Before the Timaru District Council  
Independent Hearing Commissioner

Under the Resource Management Act 1991  
In the matter of an application for resource consent by Bayhill Developments Limited

**Statement of evidence of Nigel Gilkison on behalf of Timaru Civic Trust**

1 December 2016

Illustration of potential 'reverse sensitivity' issues relating to neighbouring properties

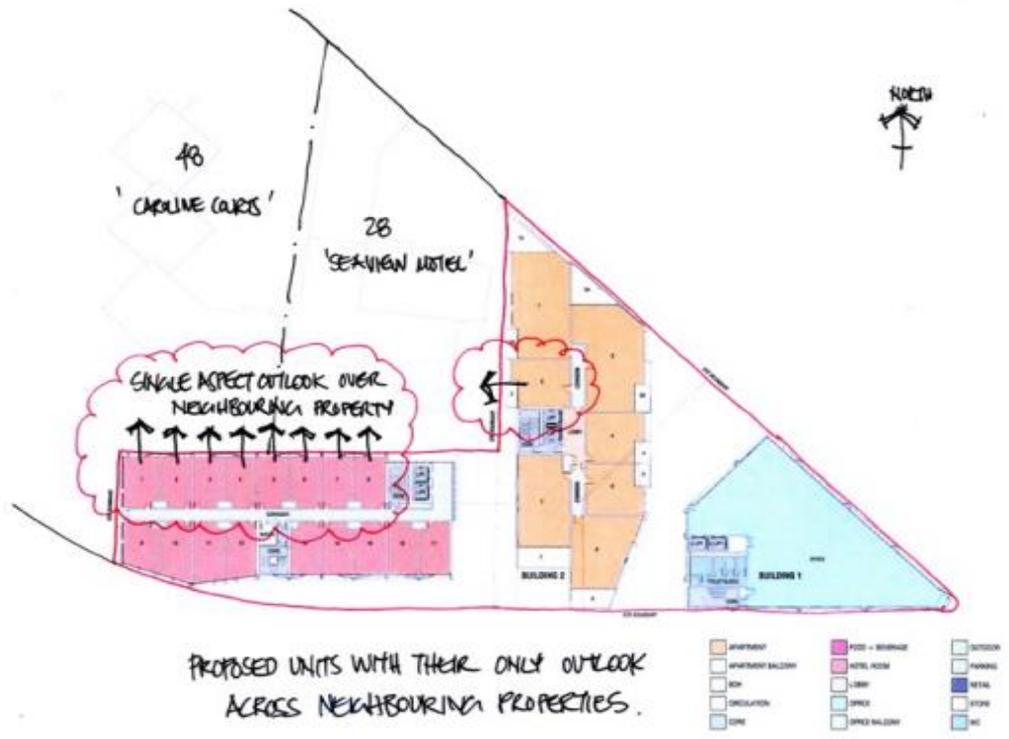
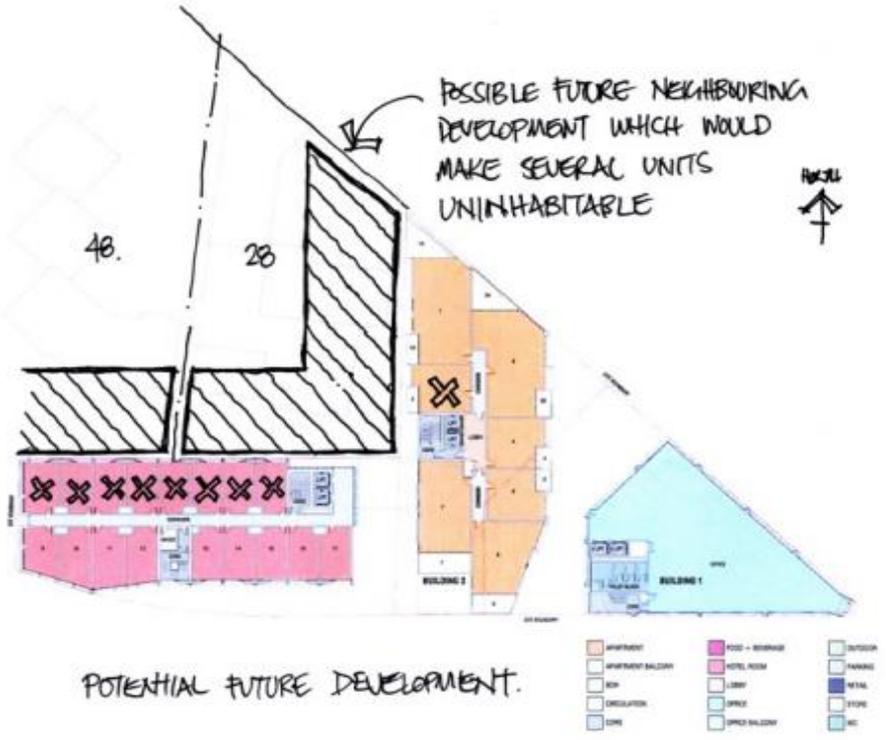
- 12 The arrangement of the proposed buildings on site, in particular, the siting of the proposed hotel, present significant **reverse sensitivity issues** due to having single aspect units which are directly facing and in close proximity to a neighbouring property boundary, meaning that these units would become uninhabitable in the future, should that neighbouring properties be developed to their full potential, at some stage in the future.

- 23 As can be seen from the Applicant's plans, the north-facing hotel rooms of Building 3 are located very close to these neighbouring boundaries, are single-aspect and are totally dependent on light and outlook acquired from the across the neighbouring properties airspace (see **Appendix 1**). Should the neighbouring properties decide to redevelop these sites to the full extent of the development envelope for their property, it is possible that these north-facing hotel rooms, within this application Site, would become completely uninhabitable and redundant.

- 24 If the proposed hotel (Building 3) is permitted to be built in the currently proposed location, this could feasibly impinge upon the rights of the neighbouring property to develop their property and potentially give rise to objections to future development by the eventual owners or operators of the proposed hotel on the application Site. I note that the report prepared by Mr Andrew Henderson, Consultant Planner for Timaru District Council, does not address this issue.

- 27 There are also similar potential reverse sensitivity issues with the siting and layout of the proposed apartment building (Building 2) in relation to the single-aspect apartments which face west, overlooking the neighbouring property of 28 The Bay Hill (Sea Breeze Motel).

- 25 In my opinion, the western part of the application Site would be better suited to an office building use, which would not necessarily be dependent on future access to light and outlook on the northern side of this part of the Site, across the neighbouring property.

- 26 In relation to the above, it would also seem more sensible and logical to utilise the corner Site (where the Hydro Grand currently stands) to accommodate either a hotel or apartments, where there are unrestricted views, outlook and access to light across Sefton Street and The Bay Hill, towards Caroline Bay.

Illustration of incorrect analysis of proposed building height in relation to existing ground level

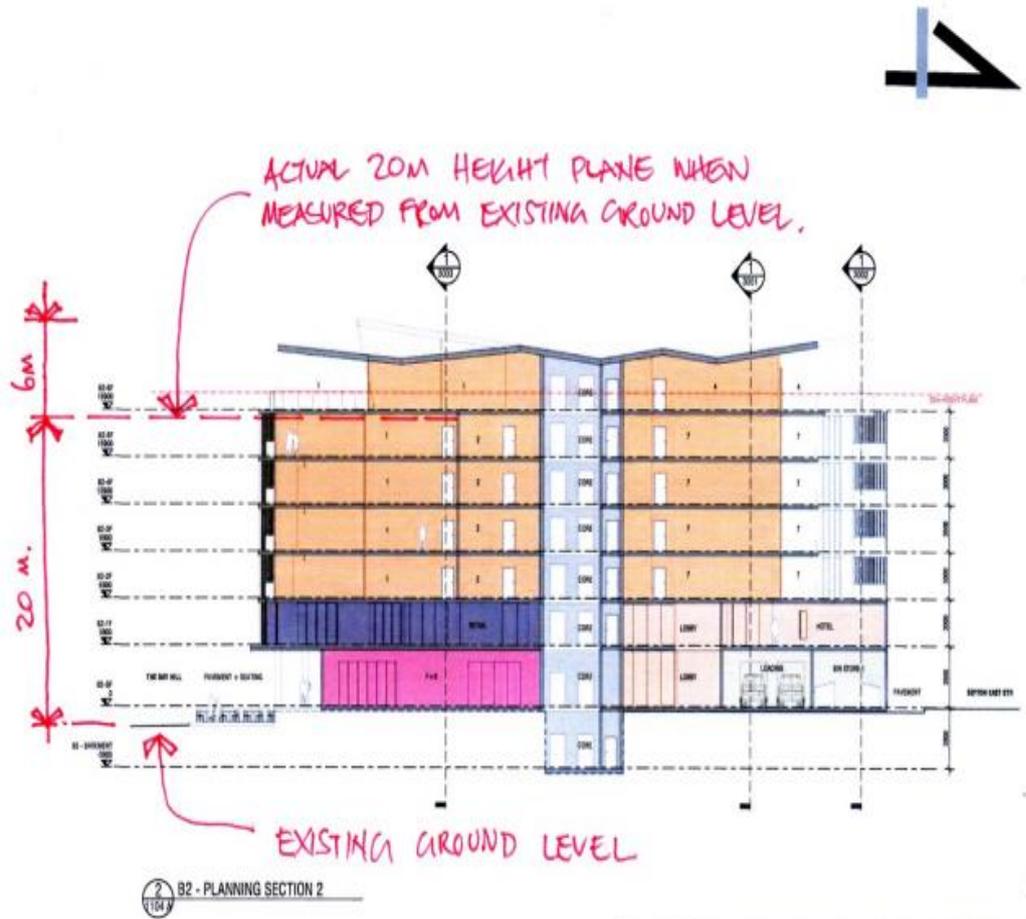
- 51 The application drawings do not clearly illustrate the existing ground lines from which a height limit should be measured, however, it is clear that there is significant penetration of all three buildings through this maximum height plane, which indicate that the building height is considerably taller than what is anticipated for this Site, by the District Plan and is therefore not consistent with the outcomes anticipated by the District Plan.

- 52 My analysis of the expected height of the proposed building, using the Applicant's own drawing section, indicates that the Applicant's stated height penetrations through the maximum height plane limit are taken from proposed ground floor level and not existing ground level (see **Appendix 2**).

- 53 The evidence by Mr Burgess for the Applicant discusses the issue of the height of the proposed buildings and states that **‘The height component over 20m is driven by the varied roofline’** (item 82). However, it would be possible to have the same varied roofline, which was below the level of the 20m height limit, if one or more of the lower stories were omitted from the proposal. I believe that the
